## 24 LOCAL AGENCY COMMENTS

# Submission 1689 (Justine Buenaflor, Bay Area Air Quality Management District, June 23, 2020)

Re: California High-Speed Rail Authority San Jose to Merced Project Section Draft EIR/EIS

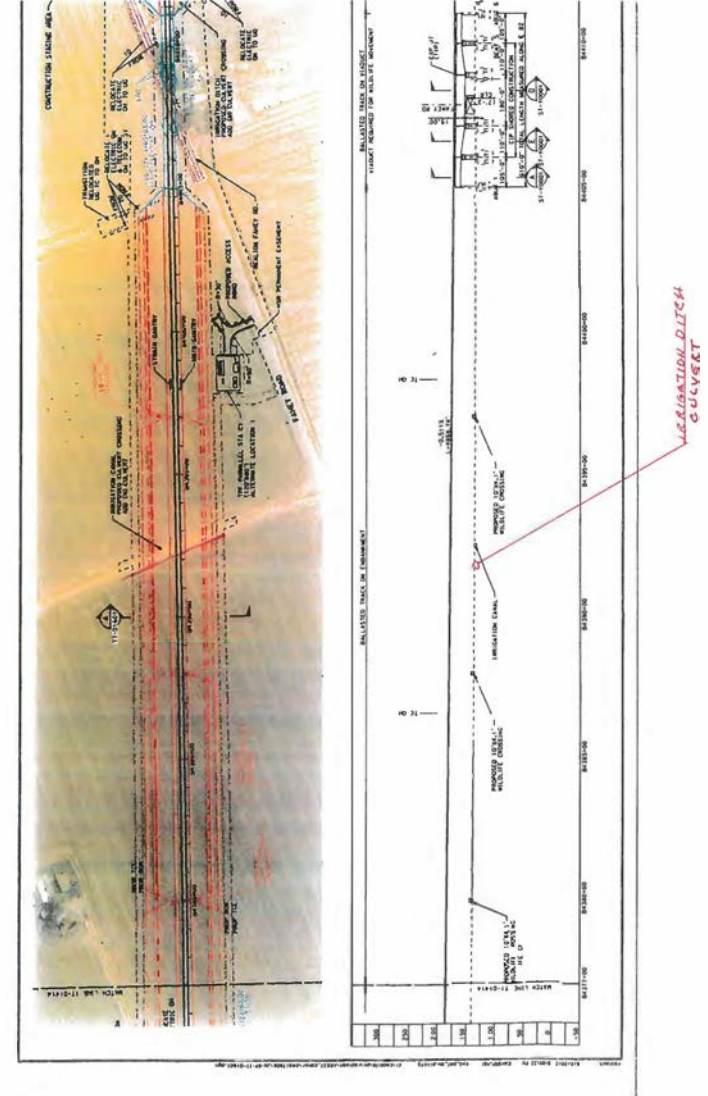
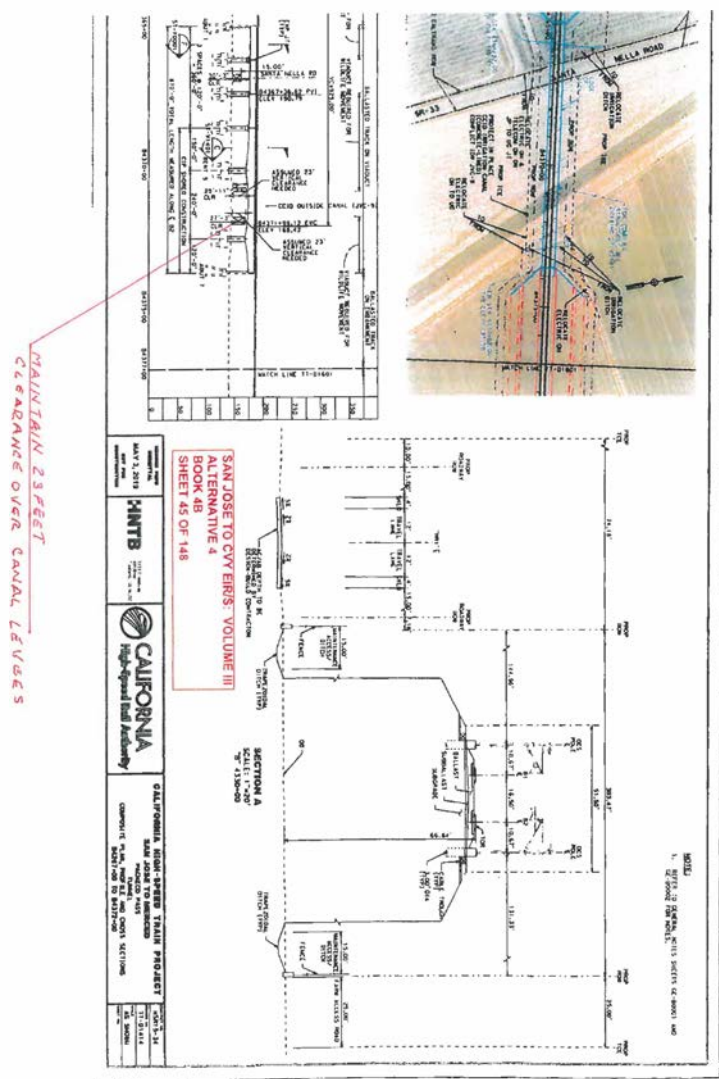
All CCID facilities shall maintain delivery capacity consistent with District operations. Design details for a structure of any kind at water channels, ditches, and culverts shall be coordinated with the District.

Attached are the draft civil plans on which we have provided our comments.

IRRIGATION DITCH CULVERT ACROSS VOLTA RD  
IRRIGATION DITCH CULVERT ACROSS HENRY MILLER RD

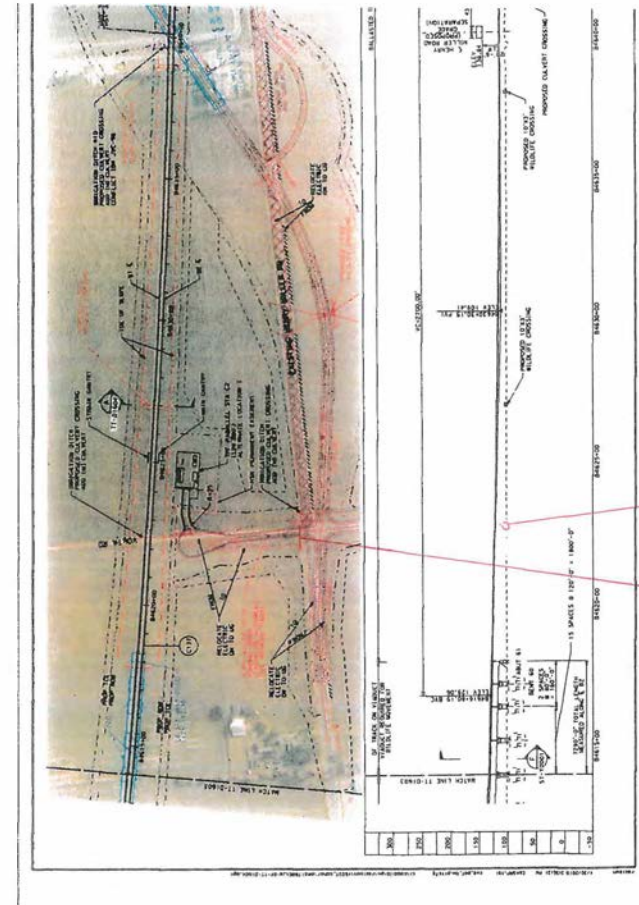
IRRIGATION DITCH CULVERT
